PACKARD MOTOR CAR COMPANY

Counselor

VOL. 25, NO. 14

DECEMBER 1, 1951

Brake Backing Plate Bolts

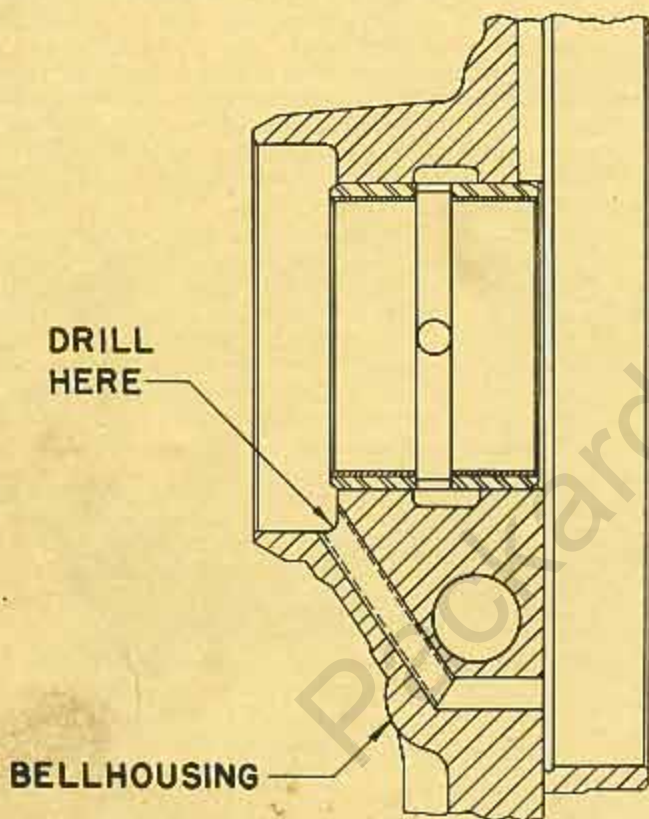
Loose rear brake backing plate bolts can cause a grease leak and a snapping noise in the brakes when applied. It may develop into a more serious trouble if the bolts are left loose.

Due to the compression of the gasket and the seating of the mating parts the bolts may require retightening after a few thousand miles of operation.

It is recommended that the backing plate bolts be checked and tightened if necessary as part of the 3000 mile inspection. They can be checked by trying to turn the bolts from the outside of the backing plate. In most cases they can be tightened from the outside without removing the wheel and drum.

Window Weatherstrip Alignment

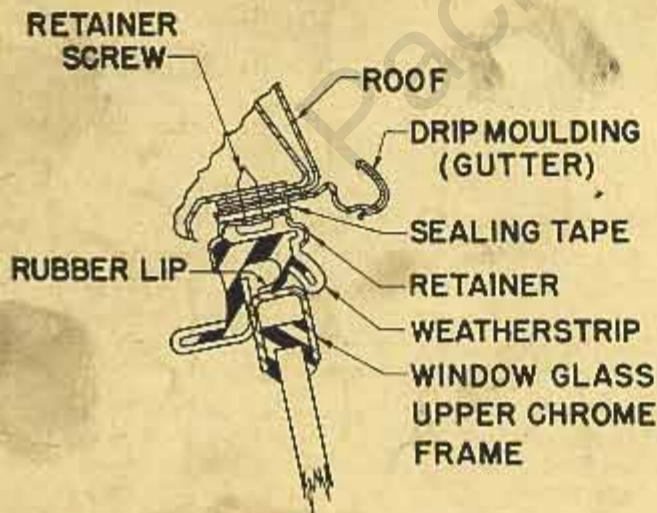
Reports have been received of incorrect alignment of the windshield pillar post and roof rail weatherstrips on the Mayfairs and Convertibles. This incorrect alignment contributes to water and air leaks around the window frames.

The cross section illustration below shows the correct fit and alignment of the weatherstrip to the vent window frame and window frames. Be sure that when closing the door, the chrome window frame rubs lightly on the outer lip of the weatherstrip and does not rub hard enough to fold the lip under. After the door is closed, the chrome window frame should rest firmly against the inner lip of the weatherstrip.

- Check the fit and alignment before removing the weatherstrip. Mark the places that need to be lowered or raised, moved in or out.
- Alignment can be obtained at times by adjusting the window stops either up or down or by tilting the window inward or outward with the adjustments that are located inside the door and behind the plugs located at the rear face of the door.
- The weatherstrip can be adjusted toward or away from the window frame by adding or removing a layer of the sealing tape. Part No. 435788 sealer tape (roll) is available through the Zone Parts Warehouse.
- The weatherstrips can be moved inward or outward by loosening the weatherstrip retainer screws and moving the retainers in the direction desired.
